# City of Portland, Maine – Building or Use Permit Application 389 Congress Street, 04101, Tel: (207) 874-8703, FAX: 874-8716

REASON FOR PERMIT: REPLACE PORCHES/DECKS

RE: Front and Side Porch Replacement; 7 Cushman Street

Application For: Certificate of Appropriateness - Front and Side Porch Replacement

SIDE PORCH ON NEARBY BUILDING - ILLUSTRATES  
PROPOSED CONFIGURATION OF NEW SIDE WALKS

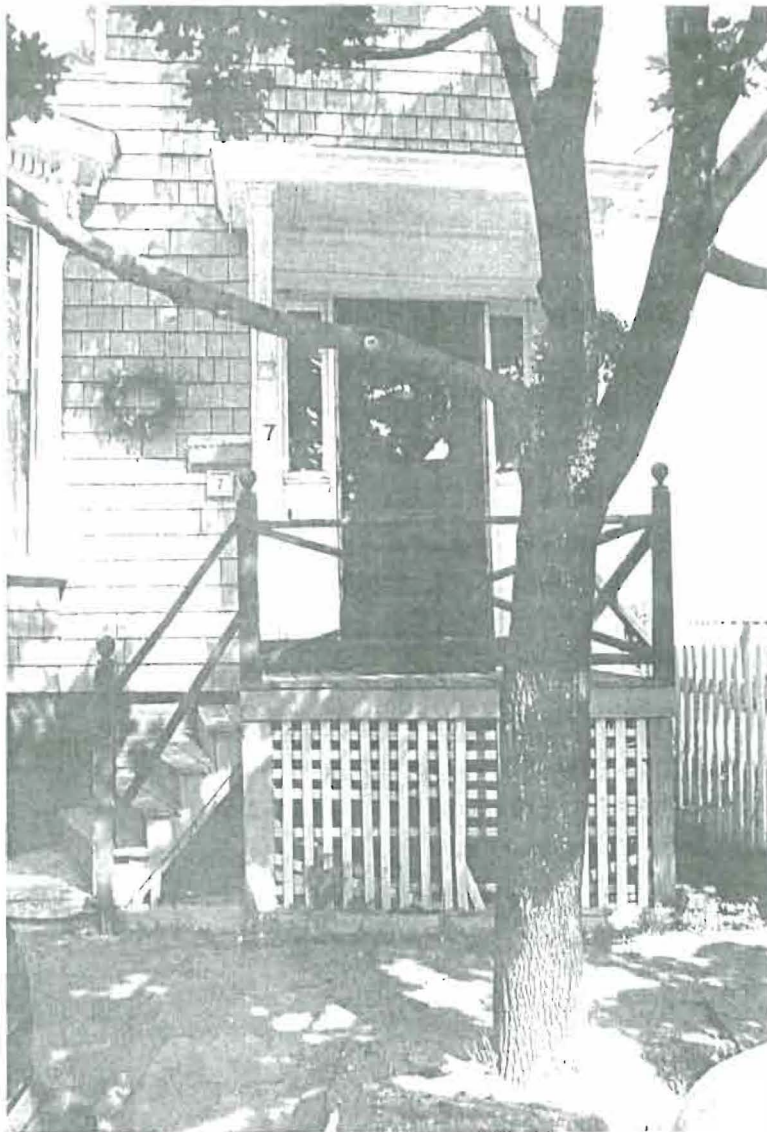
Regarding the side porch, it should be noted that the bay window on the west elevation will partially obscure the side stairs. As proposed, the existing extended deck with screening will be removed and a narrower stair will replace it. The applicant has submitted a photograph of a rear stair on another building in the neighborhood to illustrate how her proposed stair will be generally configured--that is, with an extended landing and steps running along the side wall towards the rear of the building. Staff was not able to reach the applicant to confirm whether the baluster and post details would be the same as those proposed for the front porch. The Committee will want to clarify this issue.

1. That the treads (which may be reduced in depth to 11" to accommodate limited space conditions) project slightly beyond the risers and feature a bullnose edge at both the front and side edges.
2. That a scotia molding be installed between the treads and risers.
3. That the balusters be spaced a maximum of 3" apart and be butted into the bottom and top rails.
4. That the handrail be chamfered.
5. That the side porch feature the same detailing as the front porch.

CLOSE UP OF FRONT PORCH  
(no close up of existing side porch.)

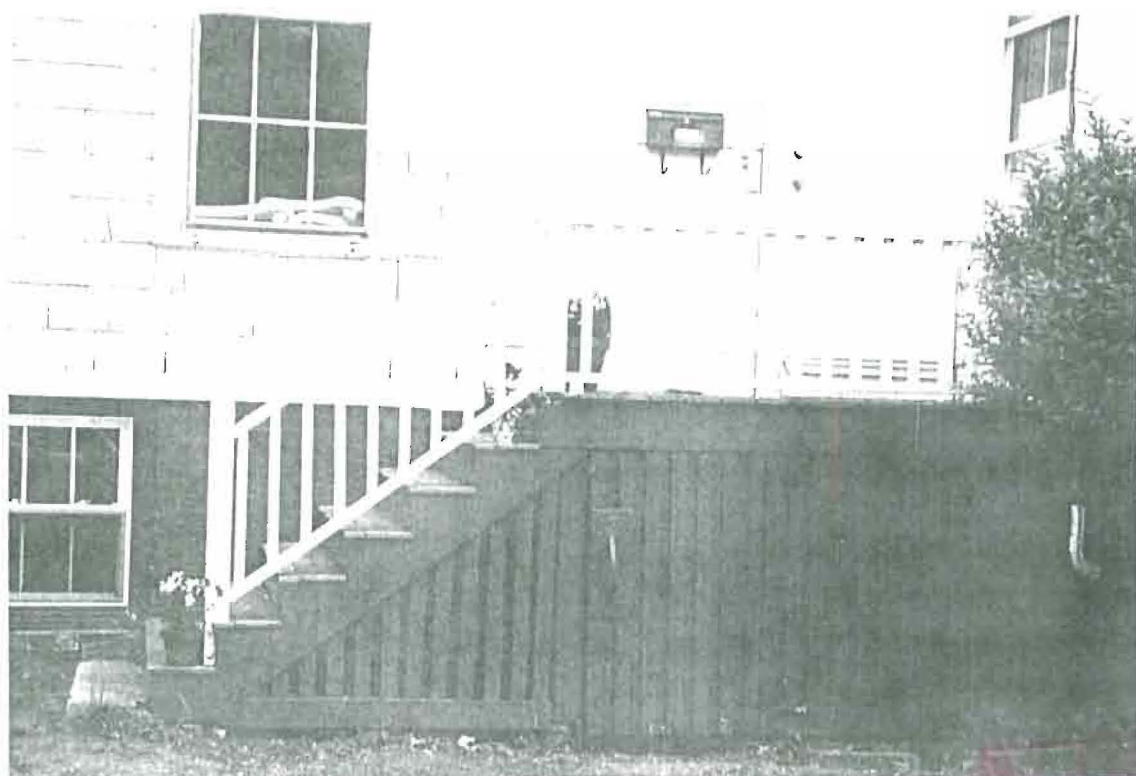
Regarding the front porch replacement, the Committee will note that the existing stairs are accessed from the side and that the landing extends the full width of the doorway and its surround combined. This creates an excessively wide porch which is not proportionate to this modestly scaled structure. The applicant proposes to replace these stairs with a straight set of stairs and has been advised by a contractor that there is sufficient room between the front facade and the sidewalk to run them straight down. The Committee will note from the submitted drawing that the balusters and front posts are similar in design to those approved for other structures of this period in the neighborhood.

While the submitted porch design appears to be generally compatible with the structure, perhaps a few modifications or clarification regarding some details is in order. For example, it is not clear from the drawing whether the handrail will be flat or chamfered. Also, the Committee has typically required that the front edge of steps extend slightly beyond the risers and be shaped and that a scotia molding be installed at the transition between the two. The Committee also might wish to clarify where the front railings will connect to the building.
